Date 31 March 2009
Page 1/8
Subject **Response to the draft** "Tool to determine the baseline efficiency of thermal or electrical energy generation systems"

We are writing this letter in response to the call for public inputs on the draft "Tool to determine the baseline efficiency of thermal or electrical energy generation systems".

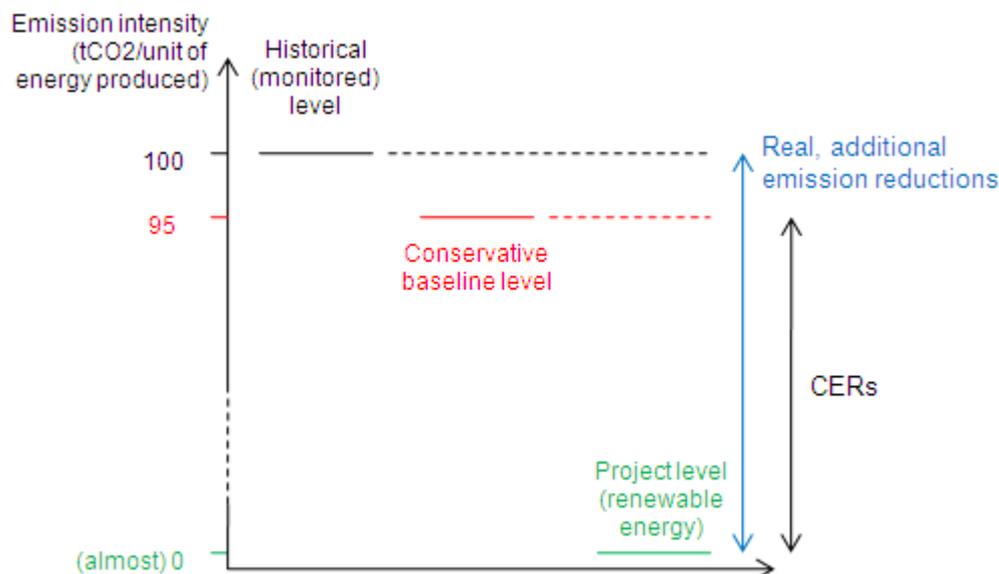
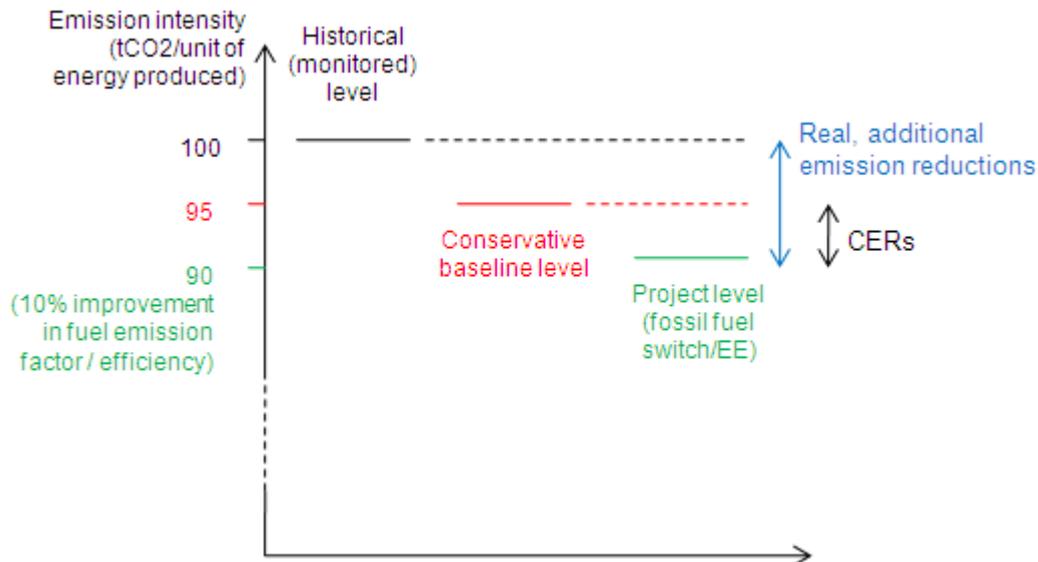
Although energy efficiency (EE) and fuel switch projects are not formally excluded from the applicability conditions of the tool, they may in some cases be effectively excluded because of the conservativeness of the tool.

Values under optimal test conditions (options b and e) and highest historical values (option c) and default values (option f)³ all over-estimate the real efficiency of the system and can easily result in a value which is more conservative than the real one by at least 5%⁴. For a project which increases the efficiency by 10% or switches to a fuel whose carbon intensity is reduced by 10%, this would effectively halve the CERs from the project, as illustrated on figure 1a below. This lower CER incentive may simply discourage the project developer from reducing their emissions. Another way of looking at it is to say that this Tool excludes from the CDM all EE/fuel switch projects which do not reduce emissions by more than 5%. The case is different

for renewable or zero-carbon energy projects, as these project types can 'afford' to have a 5% lower baseline level because the project level is (almost) 100% lower (see figure 1b below).
